Errata Sheet

V1.1, 2007-06-21

Device	**XC164CS-16F**
Marking/Step	**(E)ES-BB, BB**
Package	**PG-TQFP-100-5, P-TQFP-100-16**

This Errata Sheet describes the deviations from the current user documentation.

Figure 1 Example for Case 2: Interrupt Service for Task C delayed

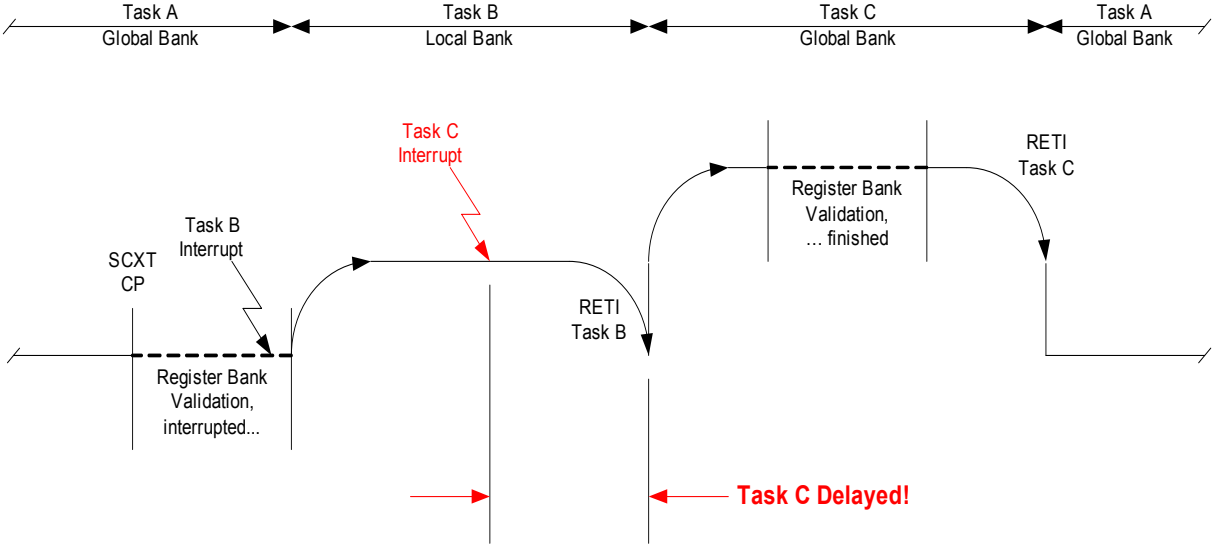
INT_X.009 Delayed Interrupt Service of Requests using a Global Bank

Service of an interrupt request using a global register bank is delayed - regardless of its priority - if it would interrupt a routine using one of the local register banks in the following situations:

Case 2 (see also Figure 1):

- The Context Pointer CP is written to (e.g. by POP, MOV, SCXT .. instructions) within a routine (Task A) that uses a **global** register bank (bit field PSW.BANK = 00_B), i.e. the context for this routine will be modified,
- This context switch procedure (19 cycles) is interrupted by an interrupt request (Task B) which is programmed (with GPRSELx = $1X_B$) to automatically use one of the **local** banks via the bank selection registers BNKSEL0..3 (i.e. the interrupting routine has a priority level ≥12),
- Before the corresponding interrupt service routine is finished, another interrupt request (Task C) occurs which is programmed (with GPRSELx = 00_B) to automatically use the **global** bank via the bank selection registers BNKSEL0..3 (i.e. the interrupting routine has a priority level ≥13)

In this case service of this interrupt request (for Task C) is delayed until bit field PSW.BANK becomes 00_B after executing the RETI instruction at the end of the routine (Task B) using the local bank.

Workaround for Case 2

When using both local and global register banks via the bank selection registers BNKSEL0..3 for interrupts on levels ≥12, ensure that there is no interrupt using a global register bank that has a higher priority than an interrupt using a local register bank.

Example 1:
Local bank interrupts are used on levels 14 and 15, no local bank interrupts on level 12 and 13. In this case, global bank interrupts on level 15 must not be used.

Example 2:
Local bank interrupts are used on level 12. In this case, no global bank interrupts must be used on levels 13, 14, 15.
